For Permit 17 June 2024
--	----------------------------

Lulu's Garden
 262 South Main Street
 Boerne, Texas

Site Plan

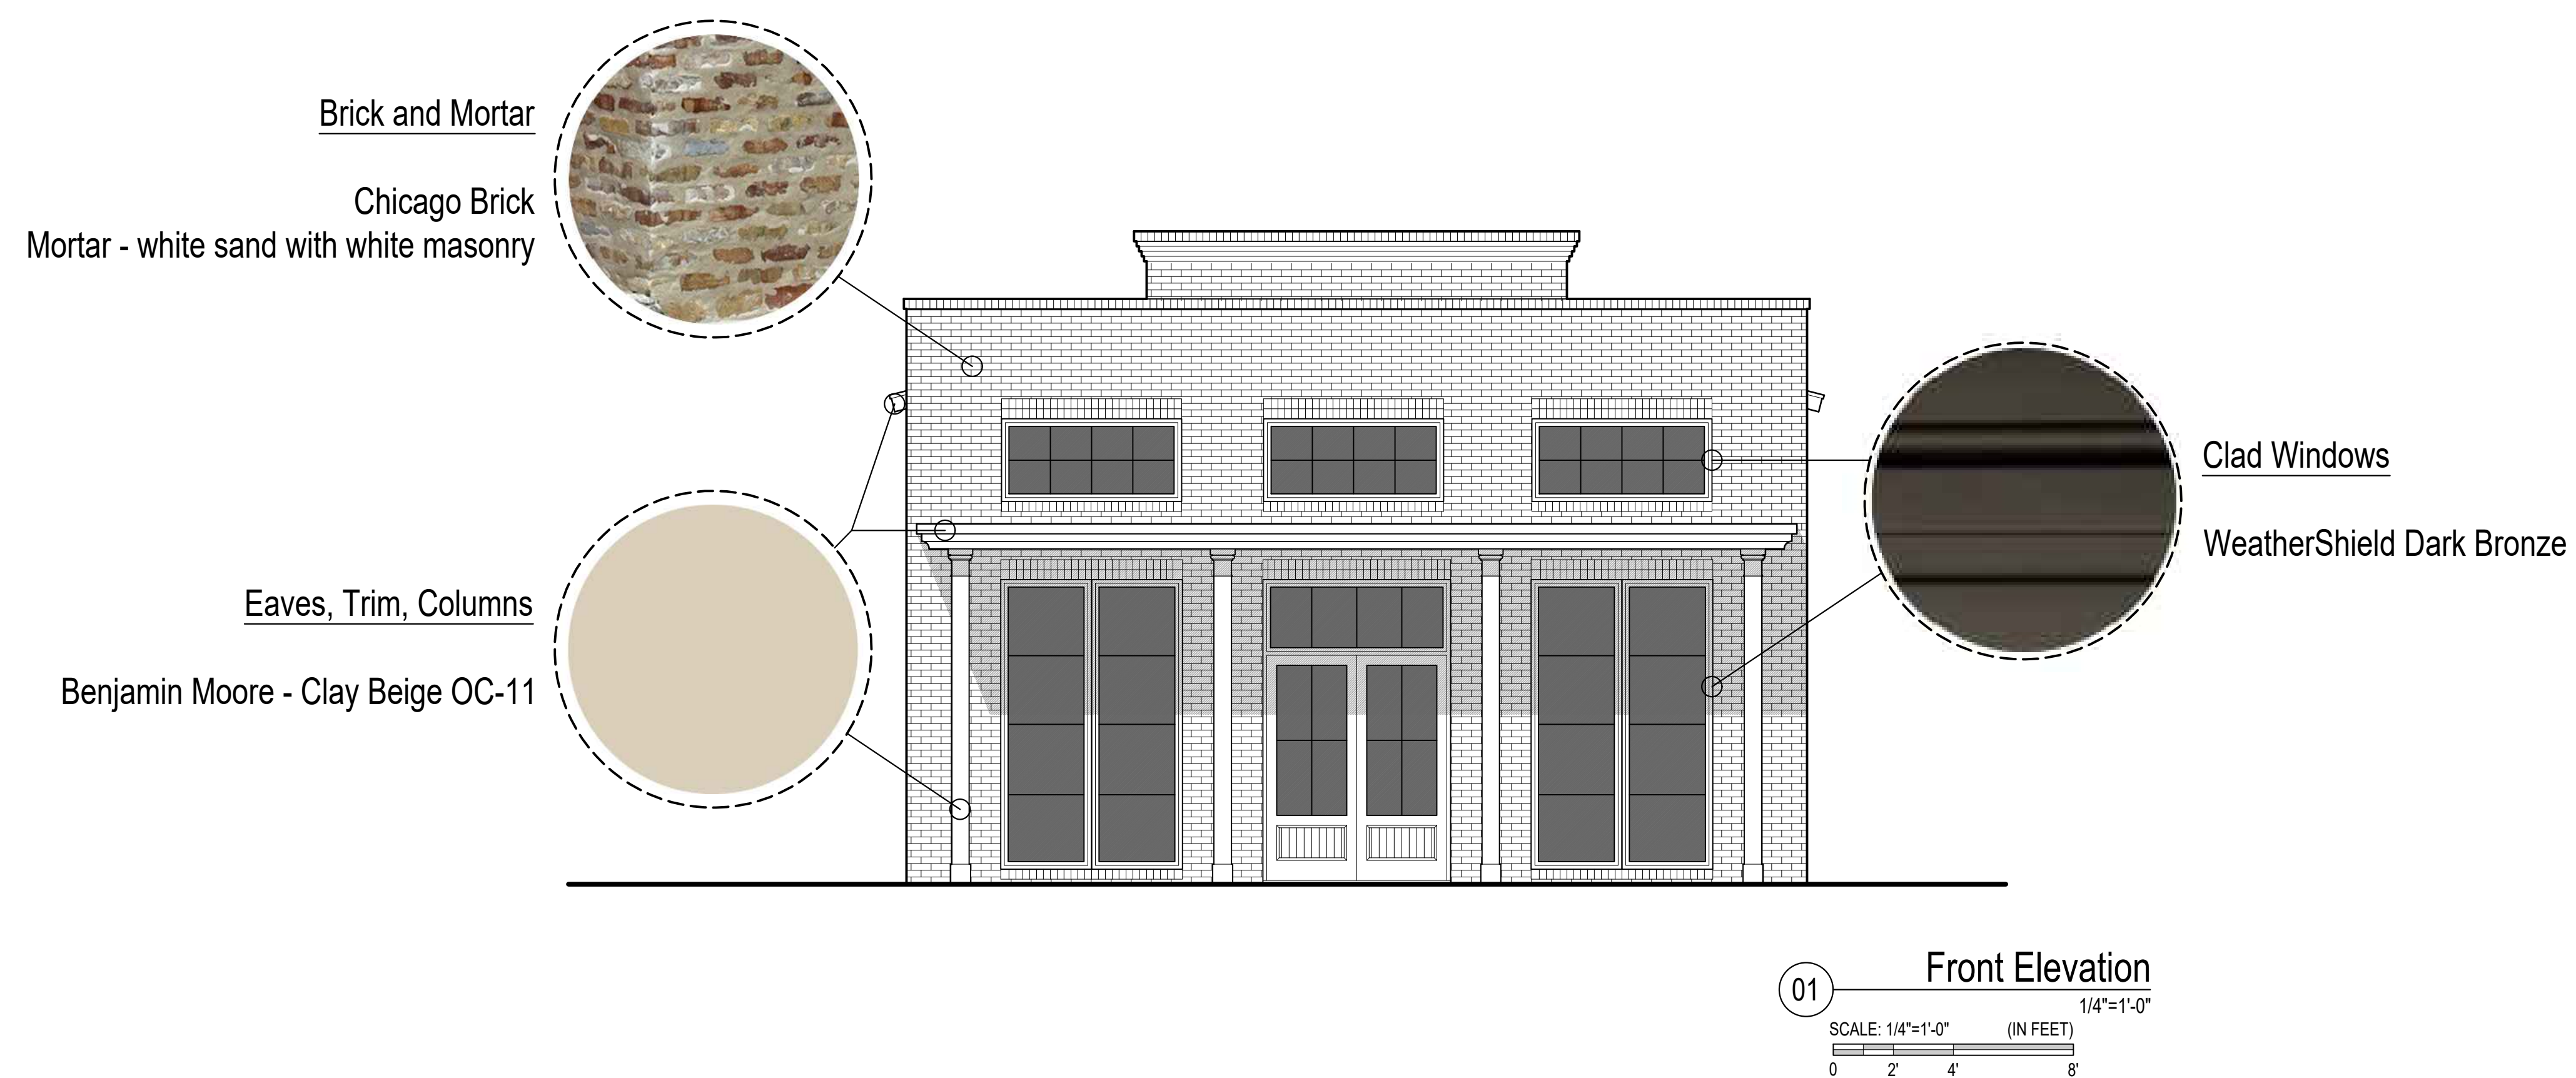
Please revise drawings to address comment about front facade window placement/height, provided on sheet 1. In addition, section 3.11.E.f. of the Historic District Overlay specifies the following building materials:

ii.If bricks are used as façade material on the building, such brick shall closely match traditional mortar and brick color tones. White or light mortars shall not be used with dark brick colors.

Please reconsider choice of white mortar in the description, to select a more historic (darker color) mortar color, - this can be achieved by mixing light cement with a small amount of red sand, to achieve more of an off-white/beige mortar color. The photo below appears to show an off-white/beige mortar color, which is fine, but the descriptions says white sand with white masonry, which is not permitted in the district. Please revise description.
